May 31, 2023

***Re: Bilal Ahmad - Application for Site Plan Approval (PB 2022-10)
2054 East Main Street, Section 23.20 Block 1 Lots 2 & 3 (the "Property")***

TITLE:	STRIPING & SIGN PLAN	
Scale:	1"=30'	
Date:	04/26/2023	
Drawn By:	KMM	
Checked By:	PJG	
Project No.:	1021	
Sheet No.:	6 of 12	
Dwg. No.:	C-301

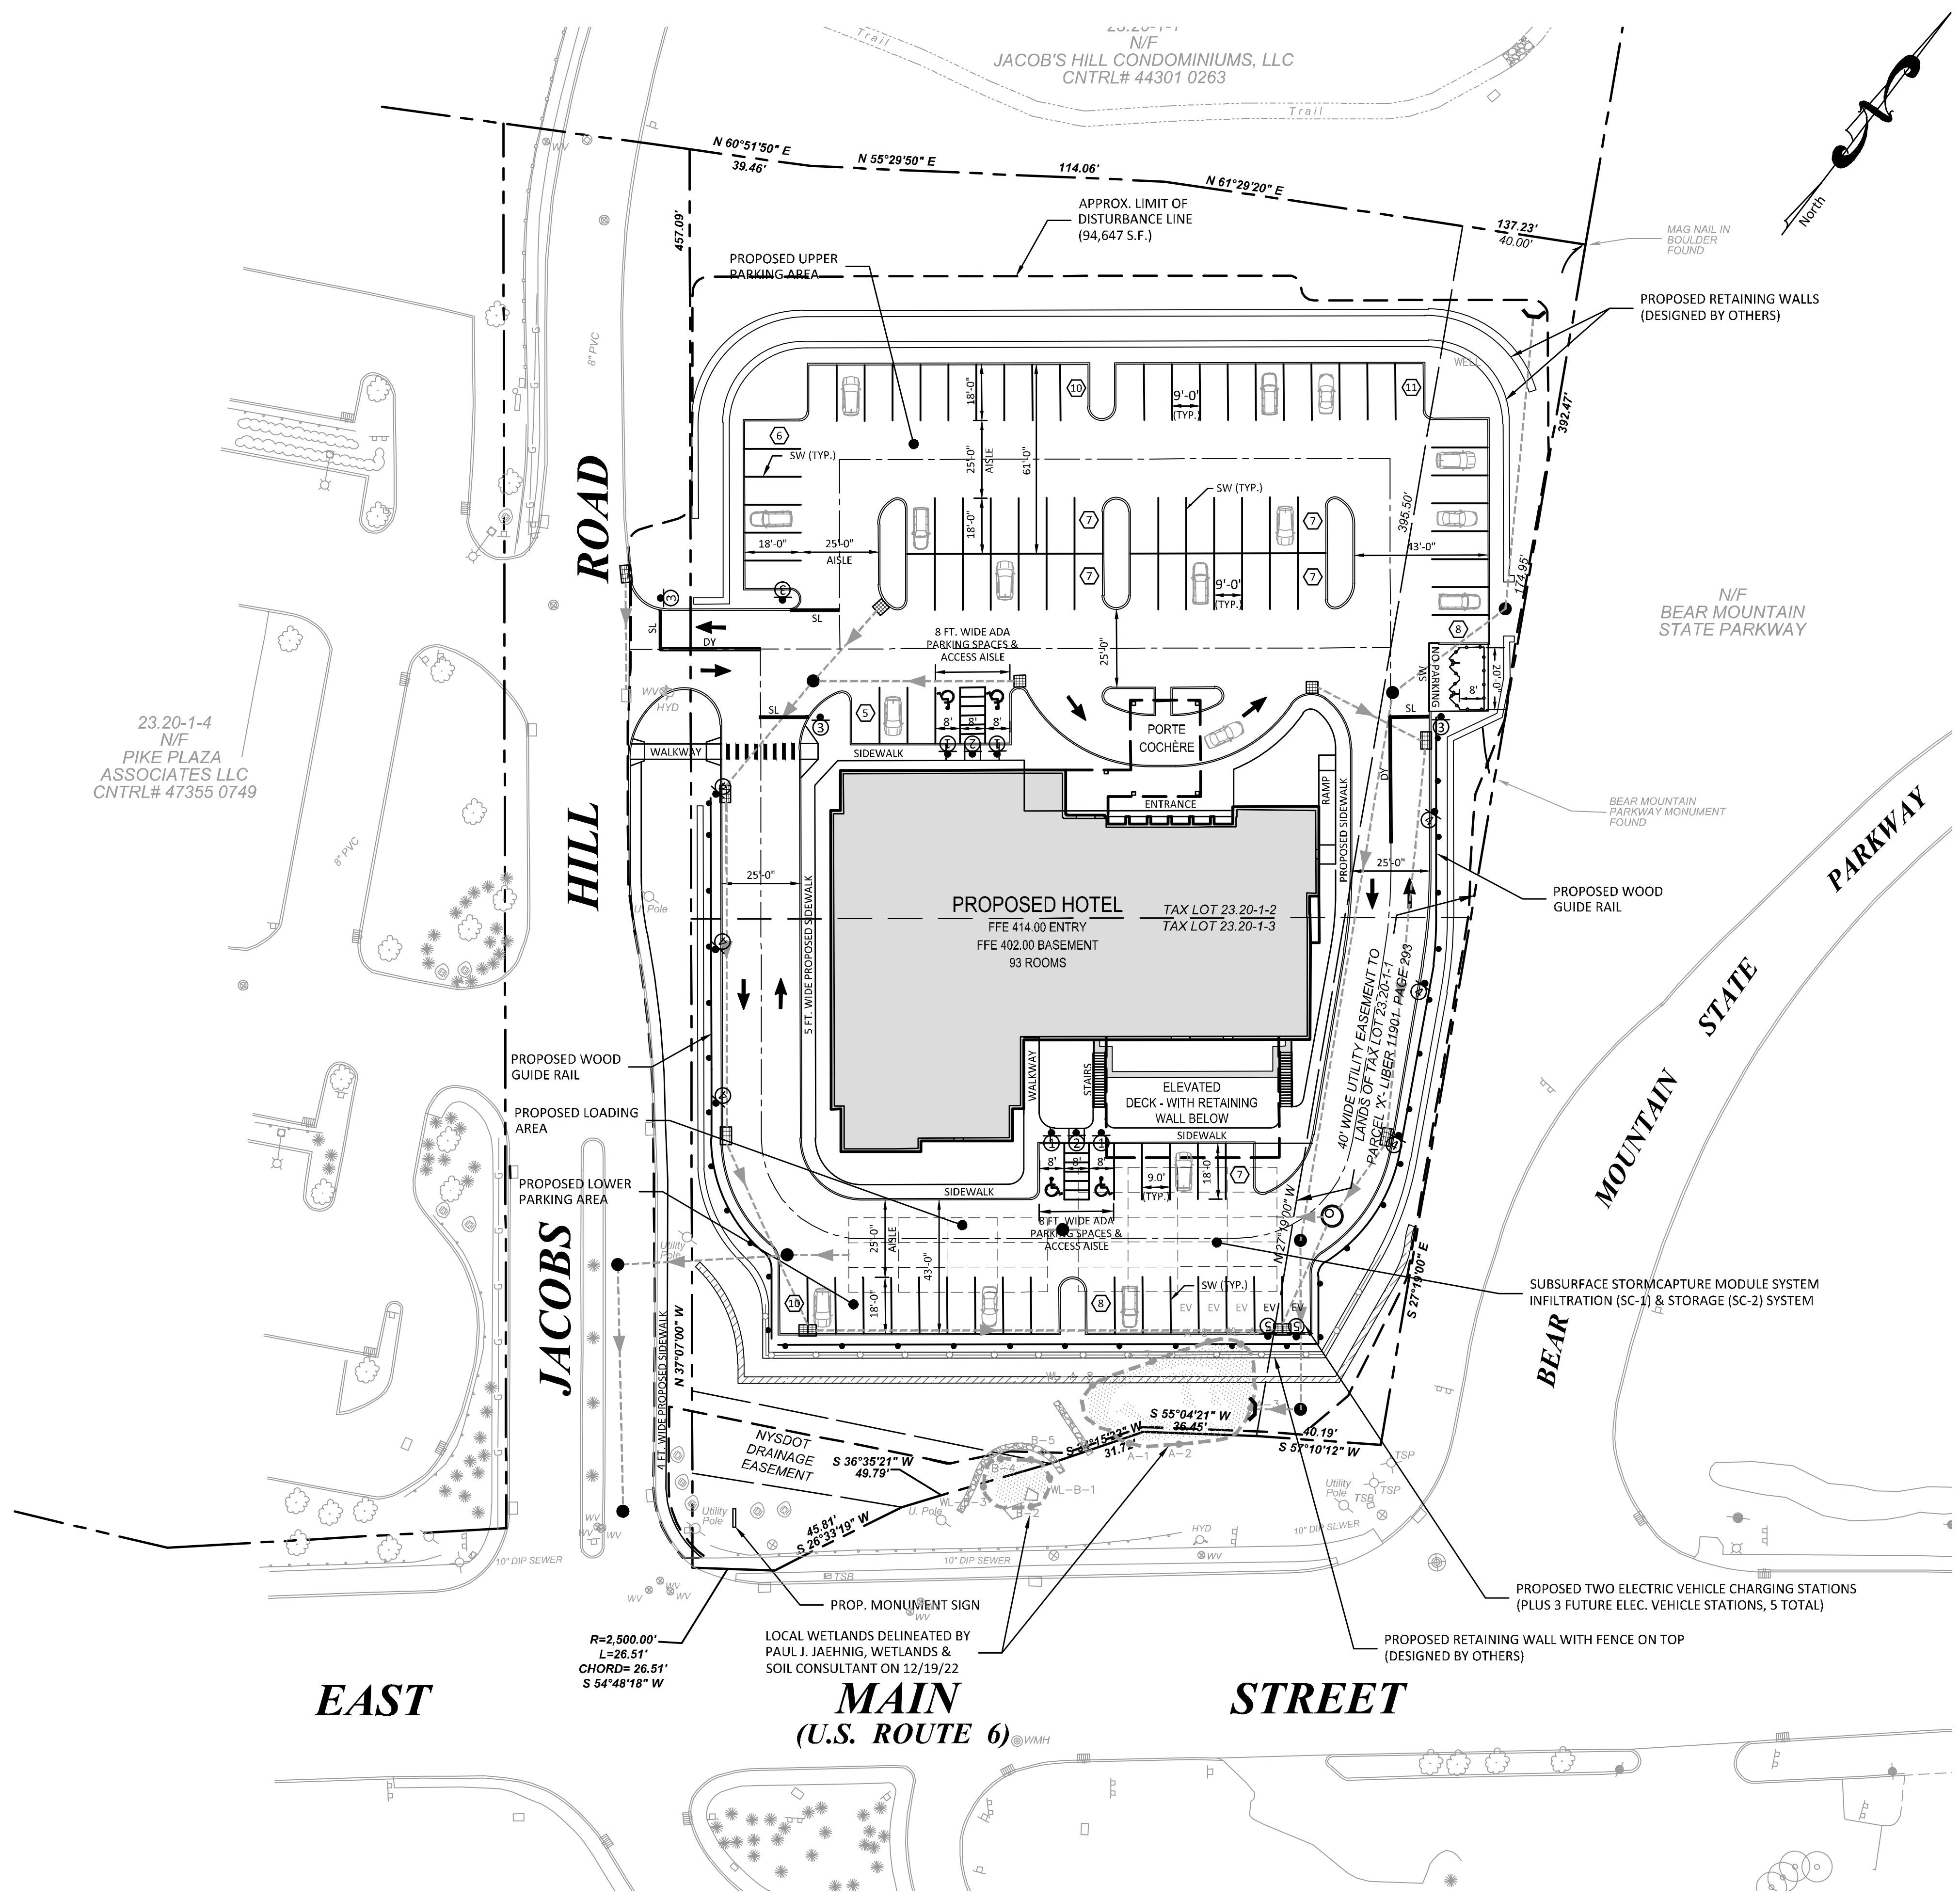
The Site Plan provides an 8-foot-deep by 20-foot-wide dumpster enclosure along the northerly side of the site's parking area. (See Sheet C-301). The dumpster enclosure will hold two dumpsters: one for recyclables and one for trash. This is standard for Marriott brand hotels of this size, and in the Applicant's experience, is adequate for the hotel's operations. A private carting company will pick up the refuse once weekly during winter months and twice weekly during the summer. Additional pickups will be scheduled as necessary upon request of hotel staff. Recycling and trash will be brought to the refuse enclosure by hotel staff using the north westerly side door, which has a ramp and connects to a walkway extending around the entire building.

The Site Plan provides two electric vehicle charging stations, located at the north-east corner of the parking area, closest to East Main Street. The Applicant proposes to install the necessary infrastructure (i.e., conduits) in the parking area during initial construction to allow for three additional charging stations if demand requires them to be installed. These additional charging stations would be located adjacent to the locations where the charging stations are proposed to be installed and are identified on the Striping and Sign Plan with an "EV." (See Sheet C-301).

- Site Plan drawing Striping & Sign Plan (Sheet No. C-301) prepared by DTS Provident Design Engineering, LLP, dated April 26, 2023, and last revised May 31, 2023.
- Stormwater Summary Report, prepared by DTS Provident Design Engineer, LLP, dated May 31, 2023.
